December 1, 2020

Re: Application of Ben's Pure Maple Products, LLC for Special Exception to allow a 16,080 sq. ft. building, etc. on Tax Map 2, Lot 17, NH Route 101 and Webster Highway

MAIN FLOOR PLAN
SCALE: 1/8" = 1'-0"

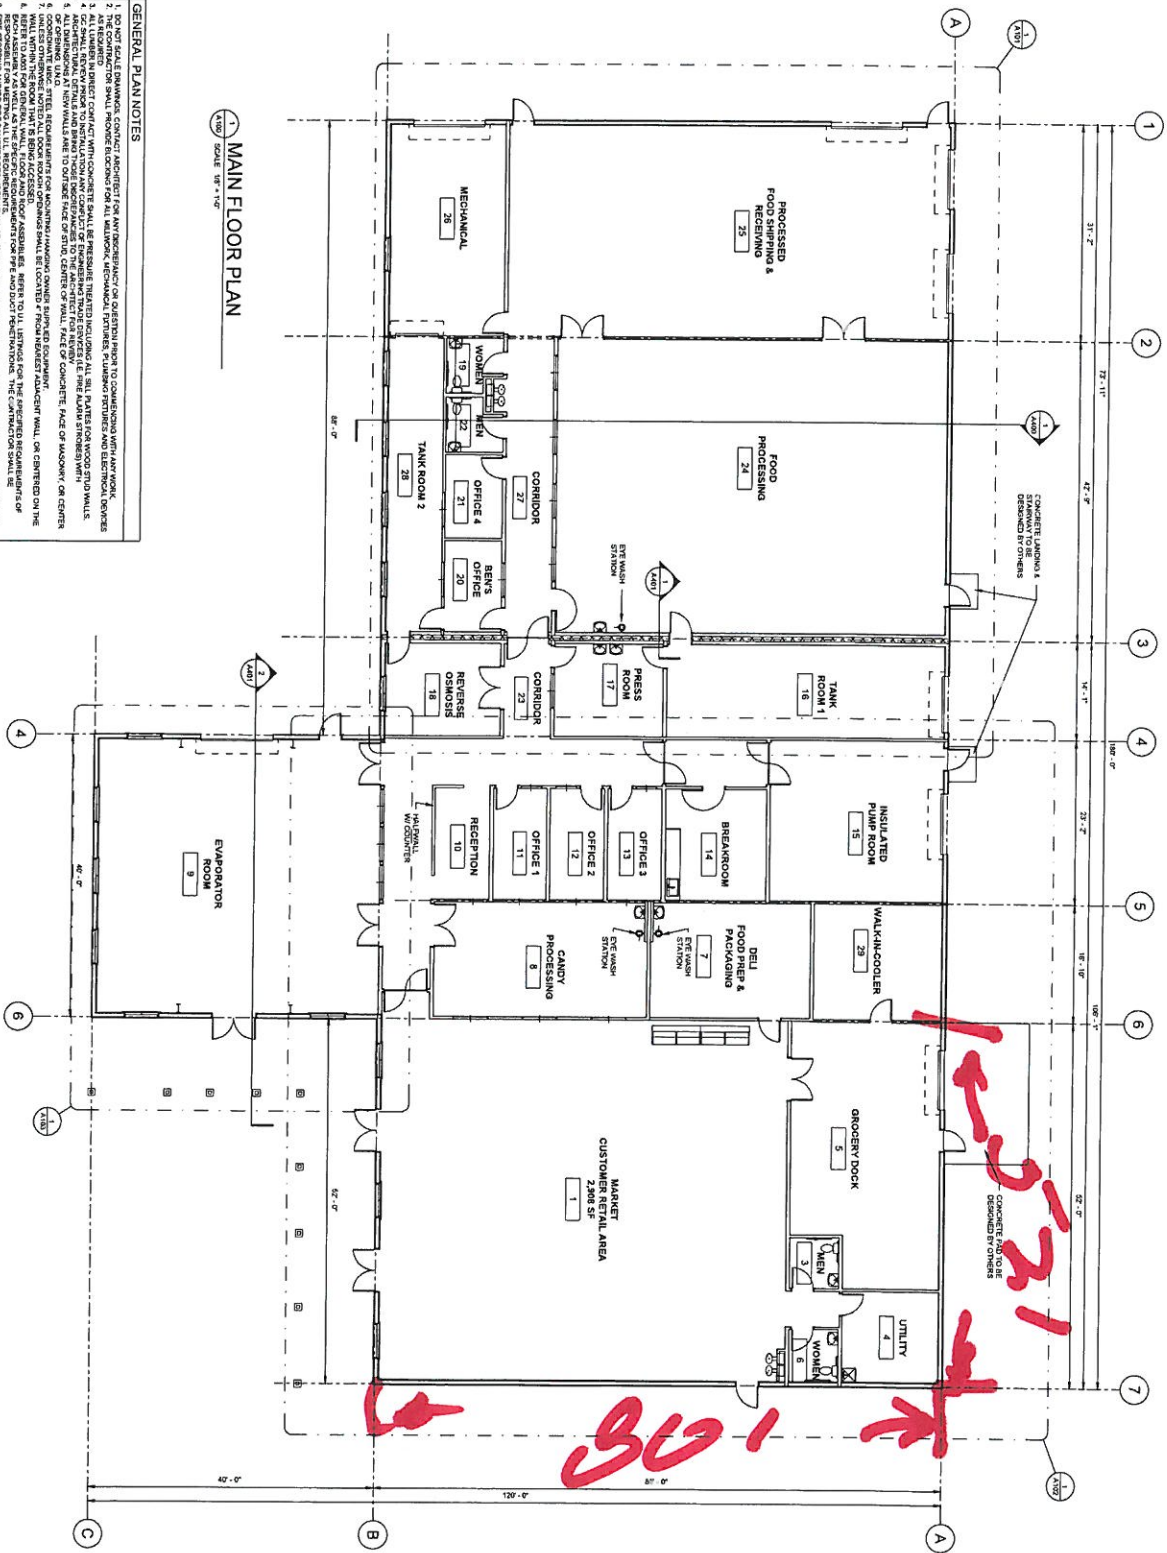
In considering whether the application meets the requirements of the zoning ordinance, the Board should view the square footage of the building which is devoted to retail operations and not to the processing of sap and syrup. Most recent floor plans submitted by the applicant shows an area

that is 68' 10" x 80' comprised of the customer retail area, the grocery dock, the utility room, lavatories, the cooler, the deli food prep and packaging. The square footage taken solely from the plans and ignoring the vestibule and ignoring any porch or other improvement is over 5,507 sq. ft. The applicant seeks to avoid compliance by providing the square footage only for the customer retail area. However, the rooms adjacent thereto are obviously serving the customer retail area and are as much a part of the retail area as the area the consumers have access to. The dimensions set forth in this letter are based upon the plans which are incomplete as to all dimensions. Just taking the area designated market customer retail area, grocery dock, utility and the men's and women's lavatories result in a square footage of 4,116 sq. ft. That does not include the walk-in cooler and the deli food prep and packaging, which are clearly part of the retail use. The Temple Zoning Ordinance defines a retail establishment and makes no distinction between the areas open to the public and the areas for the conduct of business activities associated with the public areas. The calculation of floor area for retail space needs to consider in light of this definition the entire square footage of what is devoted for the retail establishment. With respect to parking, the representation was made that there was sufficient parking, but it was not delineated on the plan. Without delineation, there is not certainty to the Board that parking with adequate aisles and traffic patterns can be placed on the site. The applicant states that a significant portion of the parking is a gravel surface. A gravel surface parking area does not serve high intense traffic. A gravel surface parking area is subject to mud seasons. Given the high water table (see septic design) and discussion of fill on which to construct the building, this site particularly will suffer at times of seasonal high ground water unless extraordinary efforts are undertaken to insure the adequacy of the gravel parking area. No such efforts are shown on the plan.
